802.3cu D1p0 TDECQ-SECQ considerations.

Background

A new transmitter parameter, TDECQ-SECQ has been introduced into D1p0 Table 151–7 applicable to 400GBASE-LR4 PMD only.

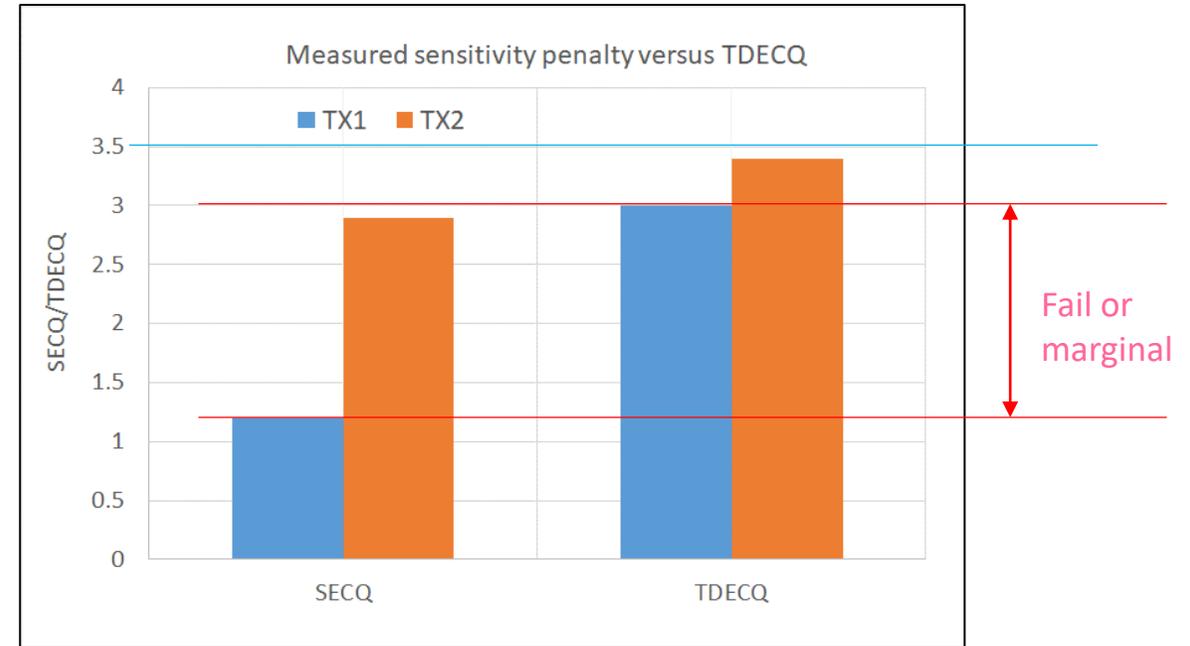
Because rely on the difference of two parameters taken under different propagation conditions.

Considering the TDECQ reference trasnmmitter, TDECQ-SECQ penalty would more easily diverge from the real receiver under propagation condition.

- SECQ (TDECQ at $km=0$) would have a better fit with real receivers, and less results variation because the 1% threshold optimization will keep it almost stable.
- While TDECQ at maximum dispersion would probably need more than 1% threshold adjustment, result is expected to be less stable considering the current .

Thus TDECQ-SECQ cannot be a very accurate metric.

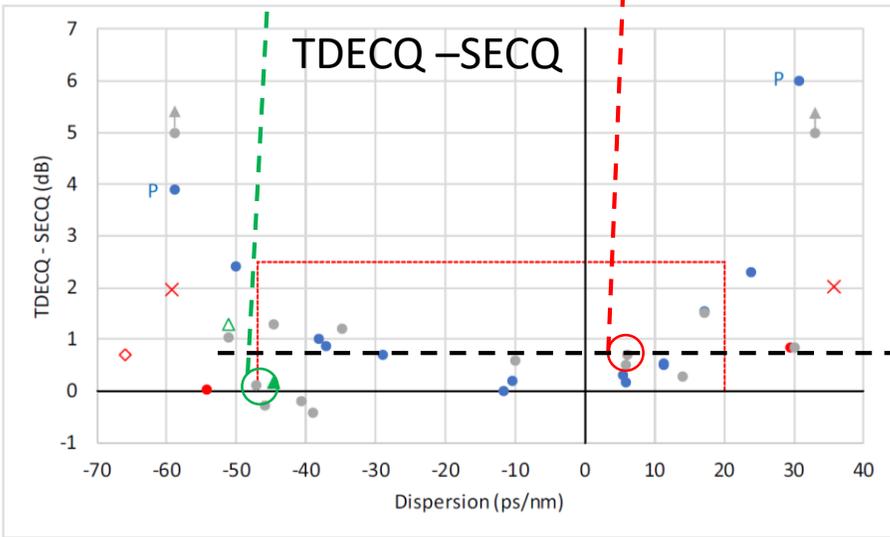
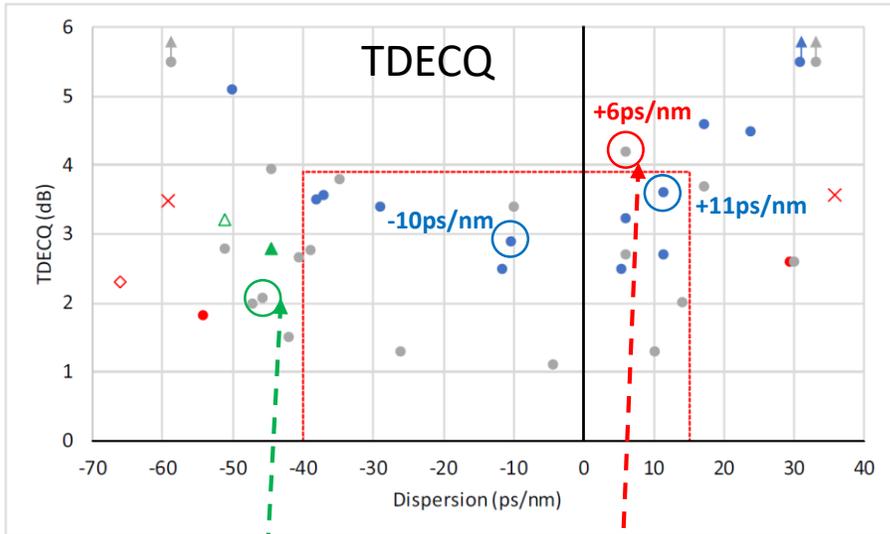
TDECQ-SECQ can potentially penalize transmitters which can still meet the absolute TDECQ at the worst case fiber propagation conditions, but fail just this new parameter. Its impact as unique parameter driving link failure has never been shown.

If TDECQ-SECQ will not be carefully quantified, what can then happen then is the absurd situation that after propagation tests a 'good' transmitter ends with lower TDECQ with respect a worse one, but just fails the new TDECQ-SECQ metric ...

Low
TDECQ-SECQ

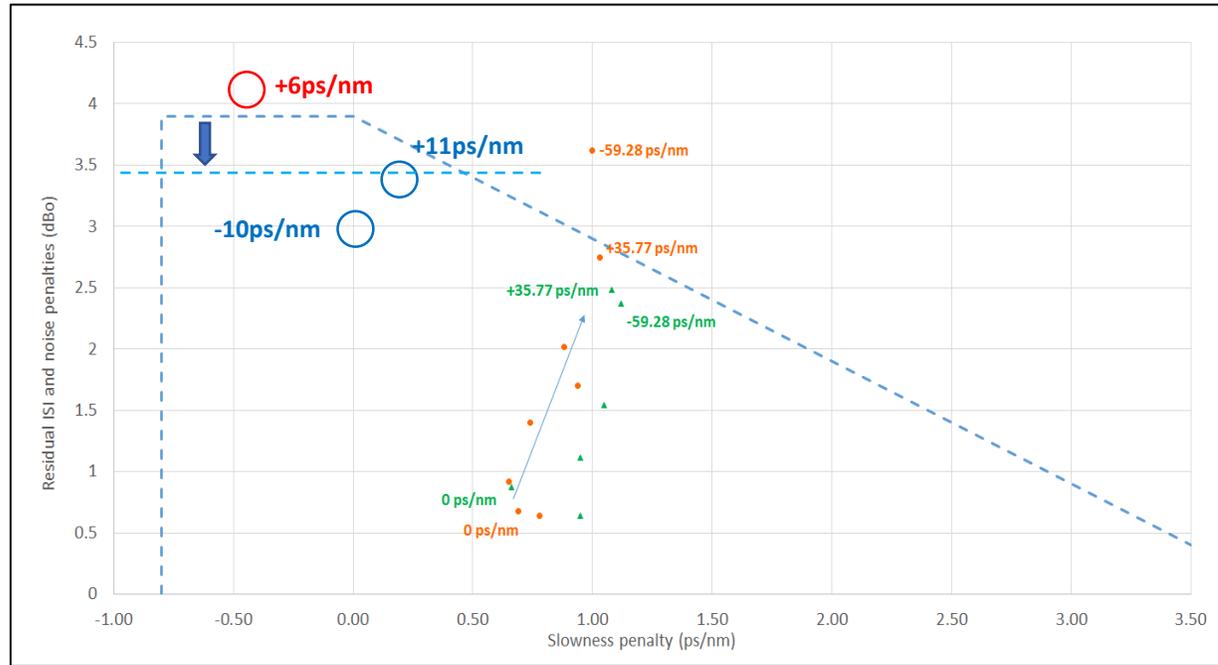
Based on same charts, the example is showing that two point at low TDECQ-SECQ have quite different TDECQ, which make clear that TDECQ-SECQ is not going to catch pre-distorted transmitter which distortion cannot be equalized.

While TDECQ-10Log(Ceq) will catch this difference, having being defined for it.

- High TDECQ and low TDECQ-SECQ (so high SECQ) -> Distortion penalty -> high TDECQ-10Log(Ceq)
- Low TDECQ and low TDECQ-SECQ -> Distortion penalty -> Low TDECQ-10Log(Ceq)
- [yu_optx 01a 0319](#) measurements

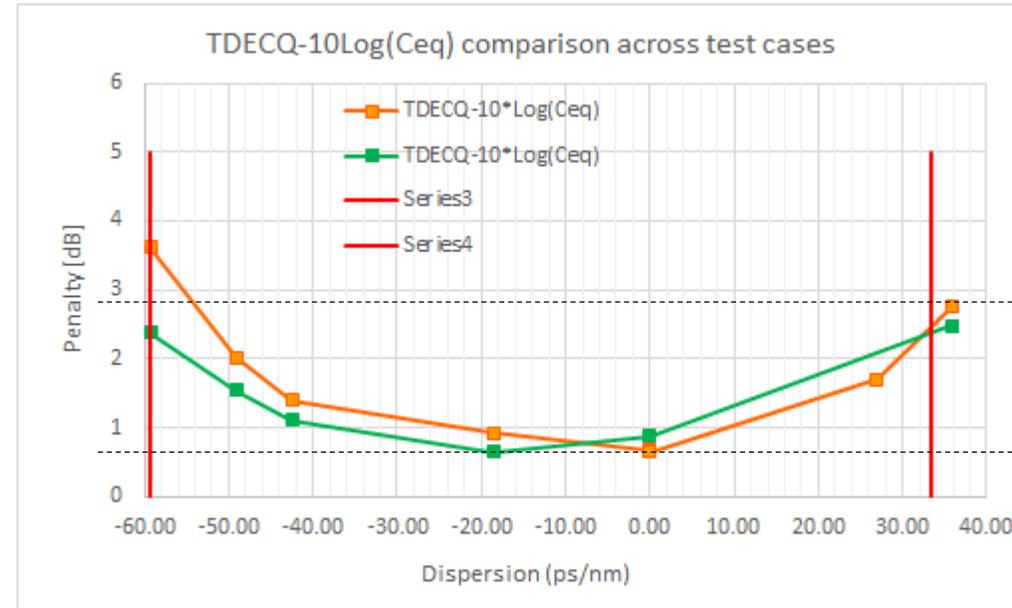
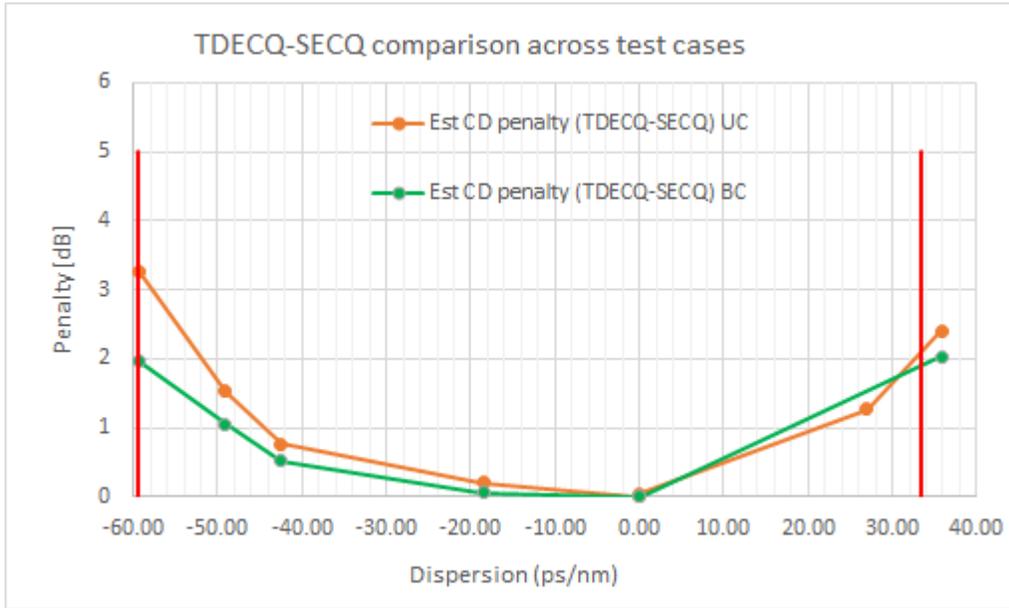
Red and Blue circles are estimations of worst cases 100G Lambda MSA and [yu optx 01a 0319](#) TDECQ and TDECQ-SECQ measurements from previous slides.

Because referring to very small dispersion, both cases seems heavily pre-distorted.

Most of the chromatic dispersion penalty goes in TDECQ-10*Log(Ceq) penalty (vertical axis).

To ensure interoperability cases, one option would to reduce TDECQ-10Log(Ceq) limit, by not aligning it with TDECQ.

TDECQ-SECQ seems a redundant parameter.

Figure 151-4—TDECQ conformance test block diagram

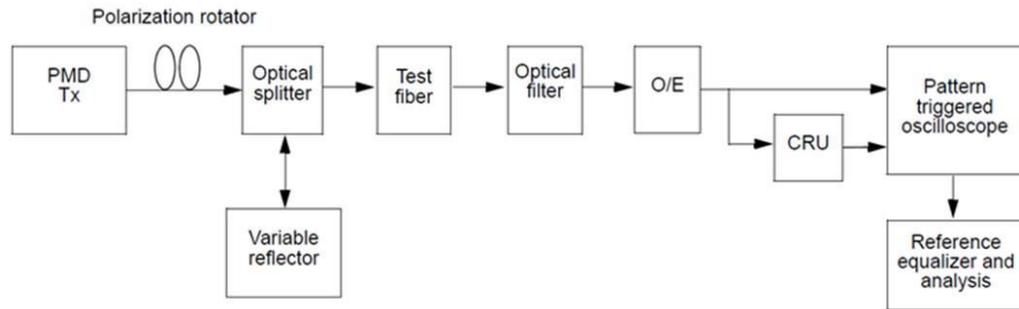
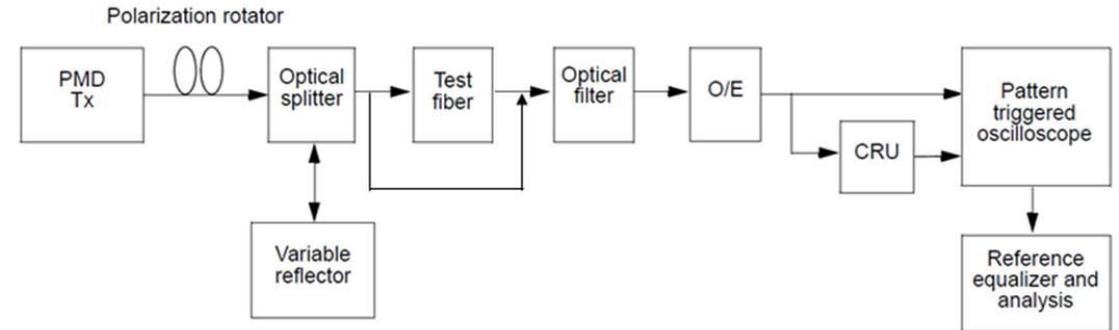
TDECQ-SECQ is a time consuming (expensive) test.

TDECQ-SECQ rely on a parameter that is been NOT defined in the transmitter, but is a receiver input requirement, used to calibrate stressed receiver sensitivity.

So, to verify this requirement, there'll be the need to verify BOTH the fiber propagation at CD limits AND the 0 ps/nm condition.

In manufacturing it will require a controlled environment in which, not only the TDECQ at the worst chromatic dispersion will have to be tested (and one can choose it own corner case test, once defined it in case), but ALSO the transmitter SECQ, run two tests: one for SECQ with 0 ps/nm dispersion and then one for TDECQ with worst case dispersion – doubling the testing time and then costs.

For multi-wavelength PMD (like 400GBASE-LR4) this will have of course more impact.
